**RE: SAMS Academy
6441 Ventana Rd. N.W.
Grading & Drainage Plan
Engineer's Stamp Date: 05/22/21
Hydrology File: A10D010**

Based upon the information provided in your submittal received 05/25/2021, the Grading & Drainage Plan **is not** approved for Building Permit, Grading Permit, and for action by the DRB on Site Plan for Building Permit. The following comments need to be addressed for approval of the above referenced project:

C 2

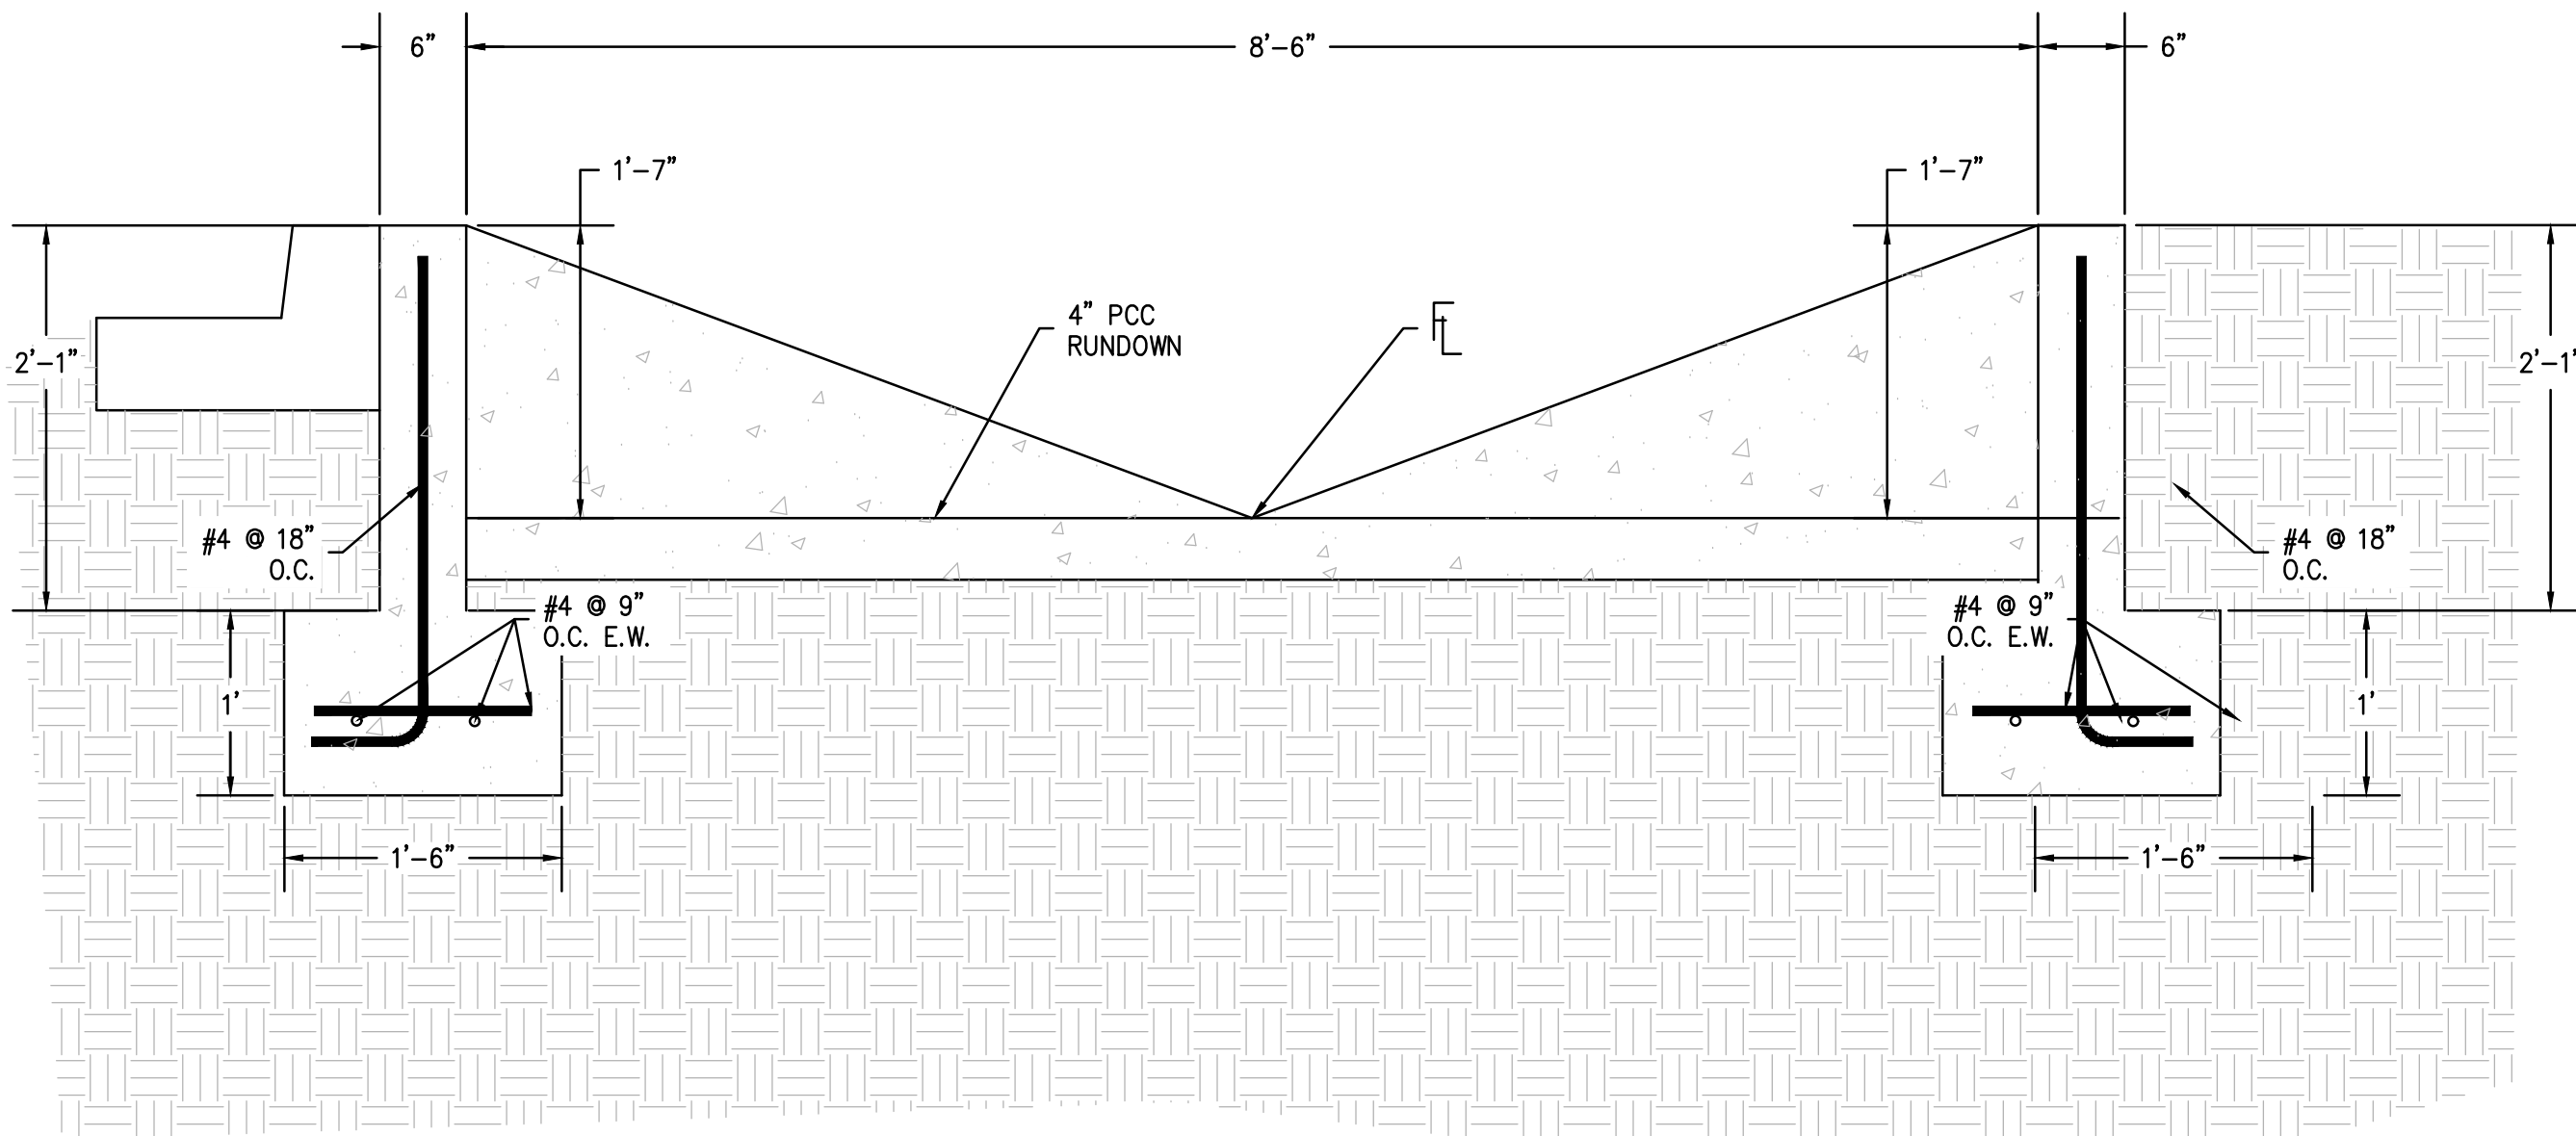
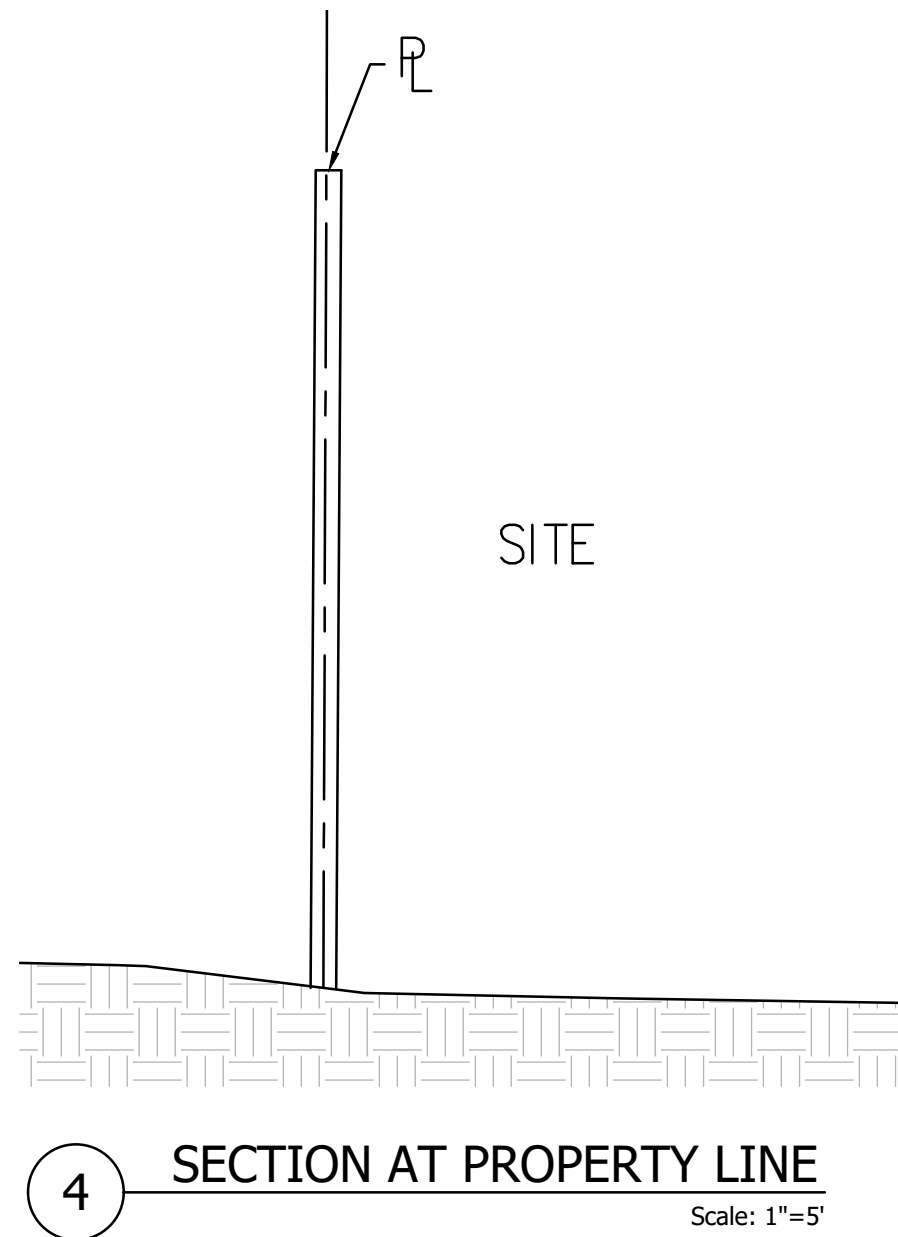
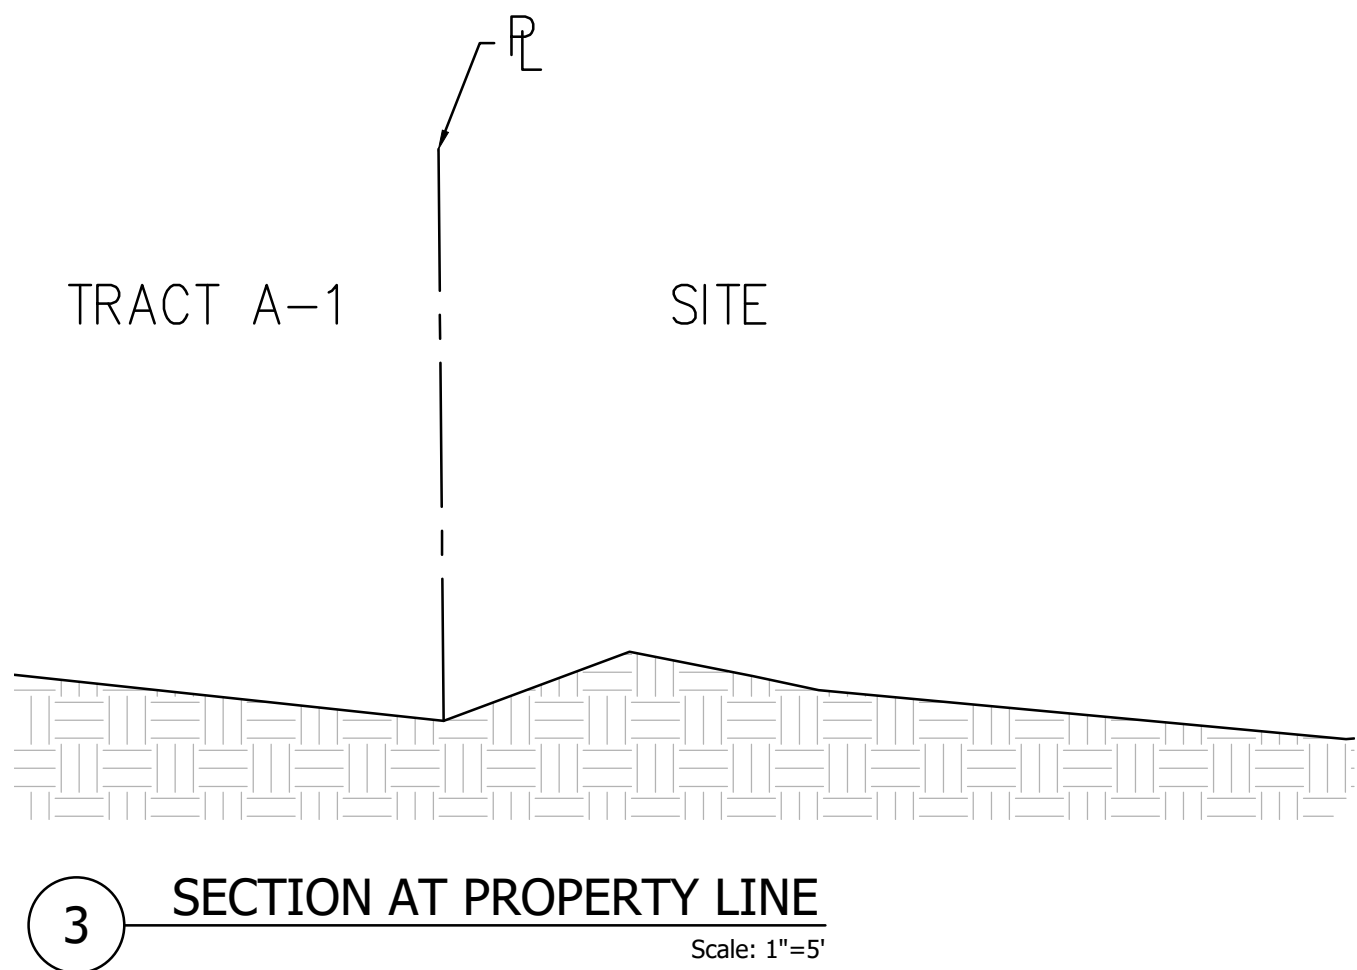
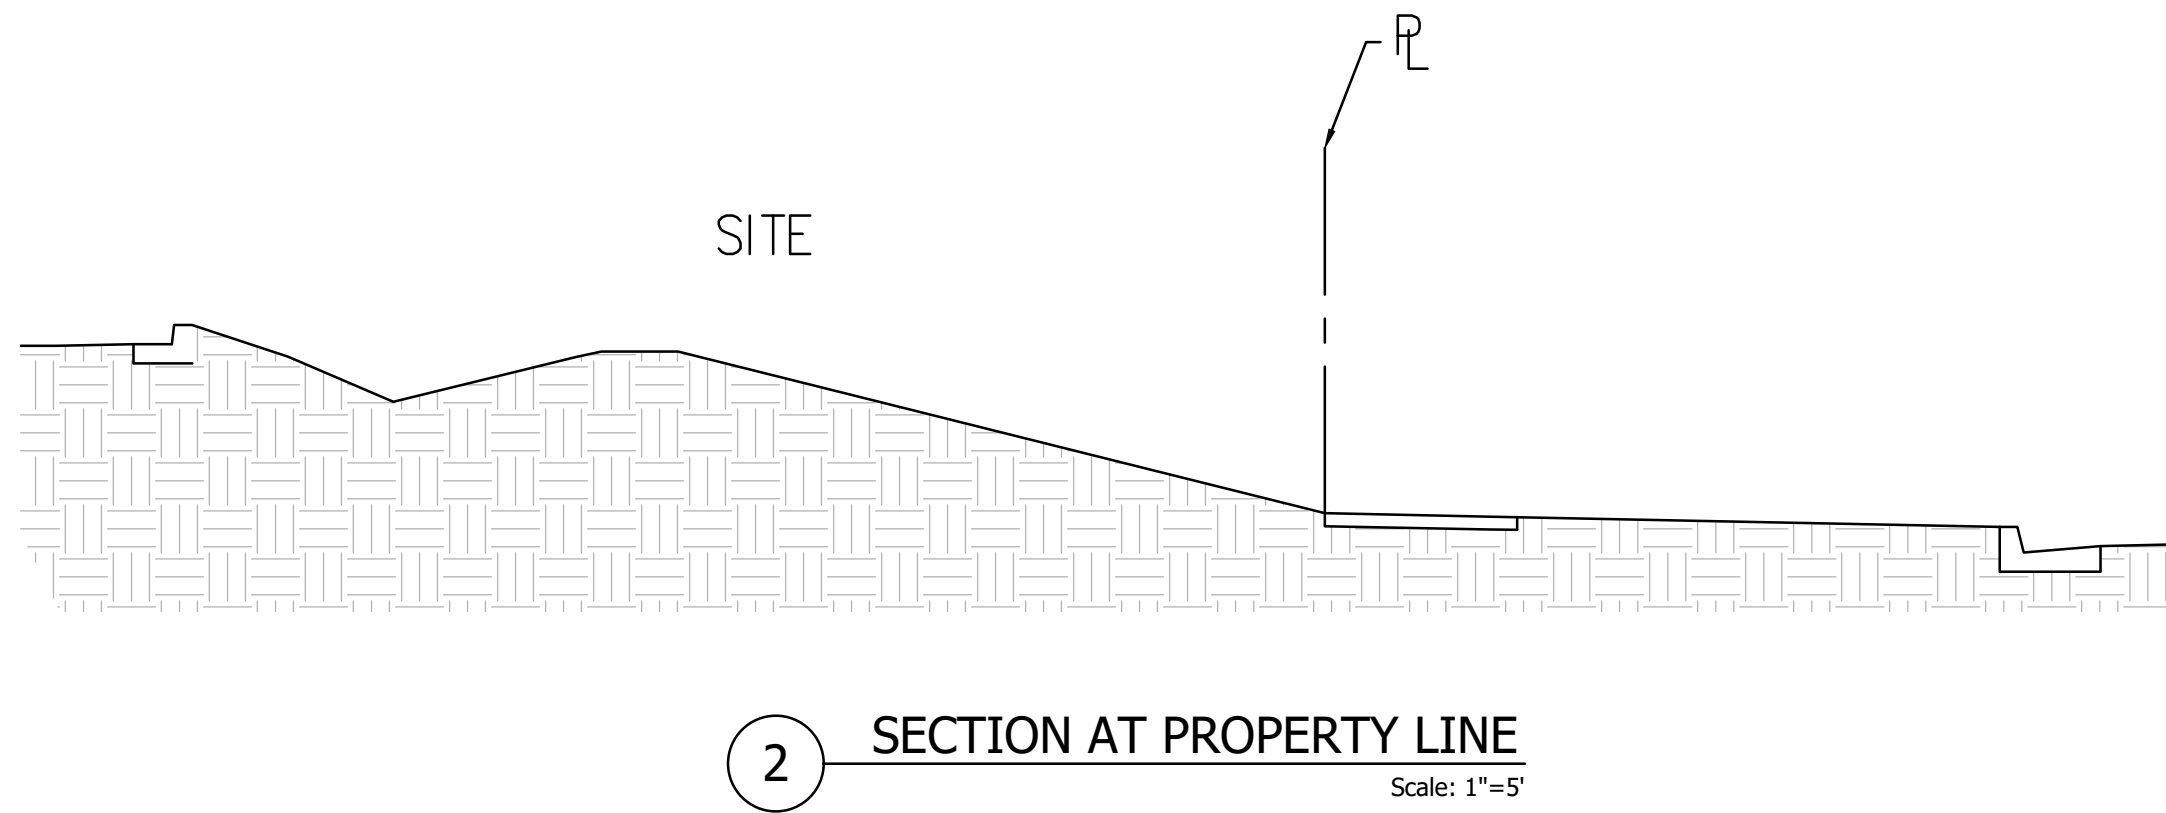
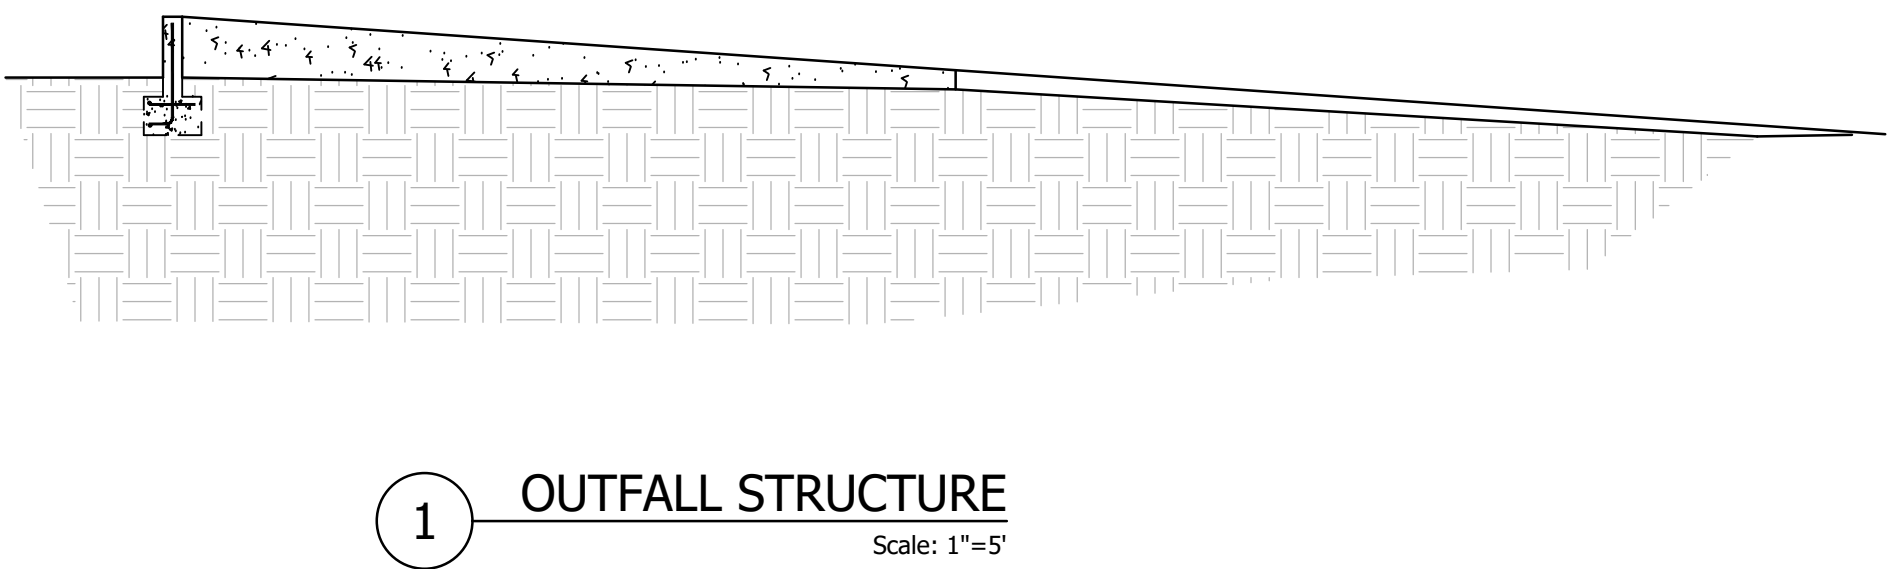
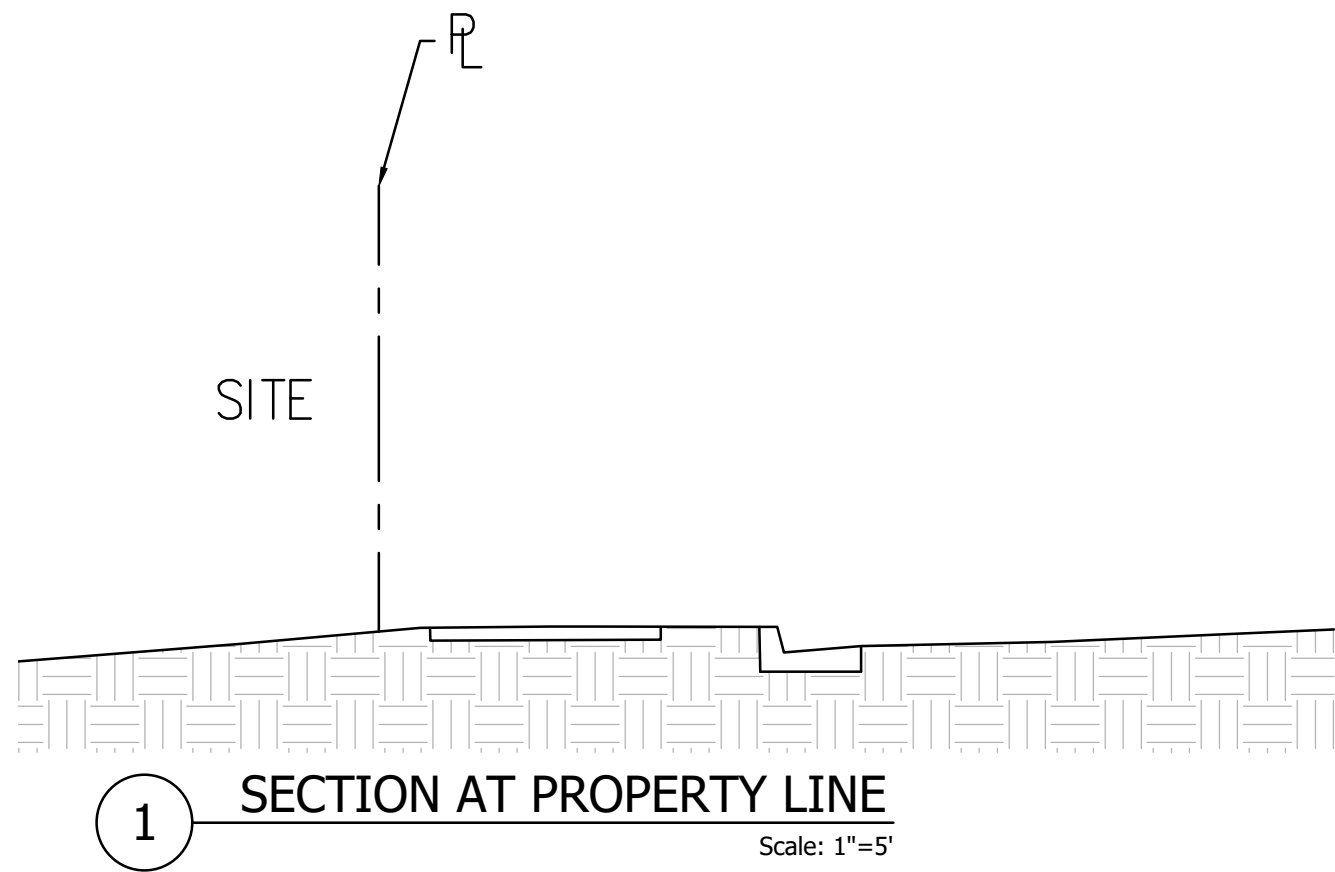
9. Sheet C2. Sections 1, 2, 3, & 4 provide no additional information to the contractor. Please remove. In this space, you may need to add both the existing drainage areas and proposed drainage areas here.

10. Sheet C2. Detail #1 - Outfall Structure. Please label the elevations at the corners of the walls. Please show the flowline (as a dash line) with the flowline elevation at both ends. Please call out see wall section this sheet. Please show the swale from the detention pond and label it. The section for this does not give any additional information if the above info is shown.

11. Sheet C2. Detail #6 – Outfall Wall Section. Please change this to Detail #2 and change the reference to it on Sheet C1.
12. As a reminder, if the project total area of disturbance (including the staging area and any work within the adjacent Right-of-Way) is 1 acre or more, then an Erosion and Sediment Control (ESC) Plan and Owner's certified Notice of Intent (NOI) is required to be submitted to the Stormwater Quality Engineer (Doug Hughes, PE, jhughes@cabq.gov , 924-3420) 14 days prior to any earth disturbance.
